ALERT SERVICE BULLETIN
Bell Helicopter **TEXTRON**

NO. 205B-04-42

MODEL AFFECTED: 205B

SUBJECT: TAIL ROTOR PITCH HORN ASSEMBLY
P/N 212-011-708-105, REPLACEMENT OF.

Figure 1
Correct Orientation of Pitch Horn Bushing

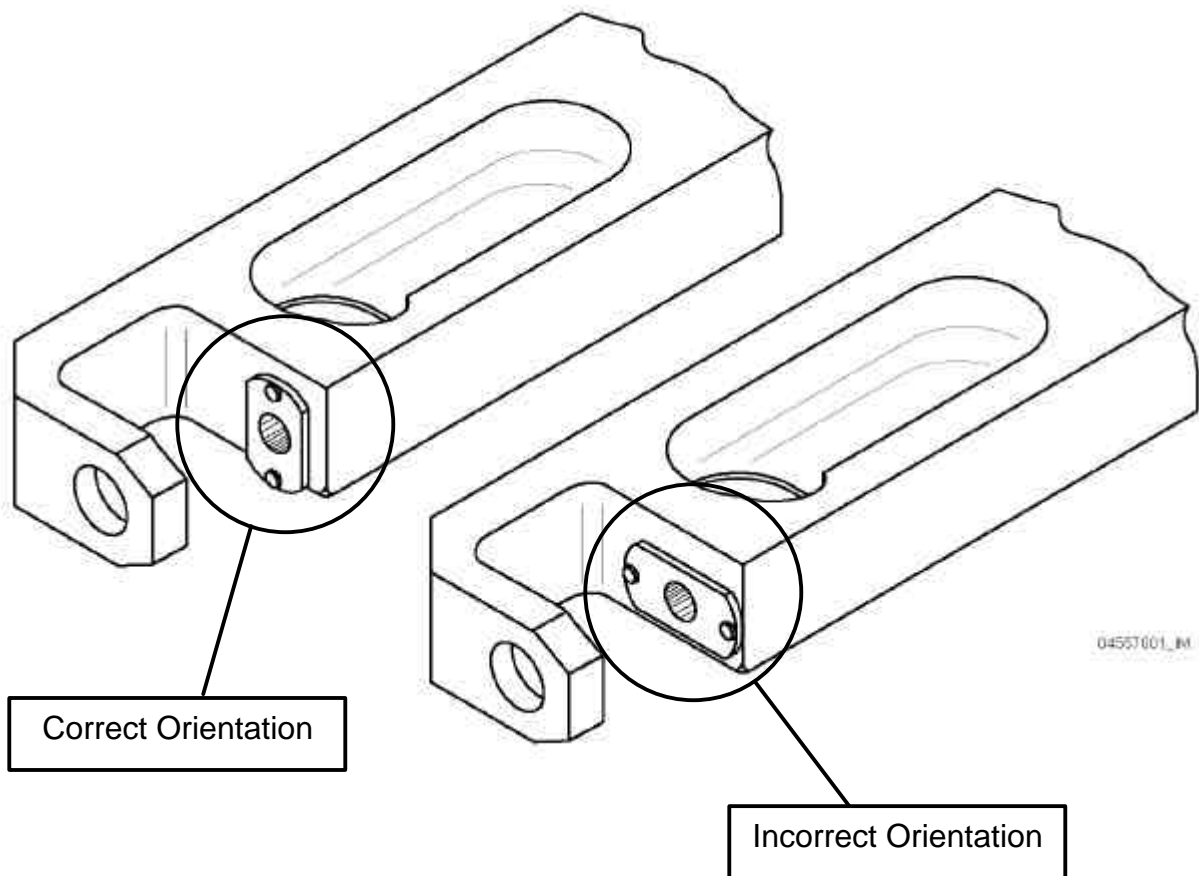
Bell Helicopter has found that subject Pitch Horns S/N TI-1 through S/N TI-113 may have incorrectly installed Bushings, which could cause the Pitch Links to contact the Bushings during Tail Rotor flapping. The resulting loads may cause excessive stress to the Pitch Horn, Pitch Link and attachment hardware between Pitch Links, Crosshead and Pitch Horn. Discrepant Pitch Horns shall be returned to Bell Helicopter, along with the mating Pitch Links and the attachment hardware. Any Pitch Horns bearing a letter "R" at the end of the affected serial number has been either reworked or found to conform, and therefore is not affected by this ASB.

1. Review historical service records and physically identify T/R pitch horn serial numbers installed on aircraft and held in spares inventory.
2. For each horn found to be within the serial number block, verify position of bushing using Figure 1. If bushing is found properly positioned, add a letter "R" at the end of the serial number, using a vibrating stylus (For example: TI-113R).

3. If bushing is found incorrectly positioned in accordance with Figure 1, remove discrepant pitch horns, mating pitch links and attaching bolts (20-057-5-14D & NAS6605H20) and return to Bell Helicopter for credit. Remove any chordwise

4. Re-assemble Tail Rotor Hub & Blade Assembly as required by replacing discrepant parts with new and/or serviceable pitch horns, pitch links and attachment hardware between pitch horn and pitch link and crosshead to pitch link. Dynamic balance as required after installation.
5. All discrepant pitch horns serial number TI-1 through TI-113 that have never seen service on an aircraft may be reworked at Bell Helicopter. Reworked pitch horns will have a letter "R" at the end of the serial number.
6. Annotate historical records to show compliance with this bulletin.
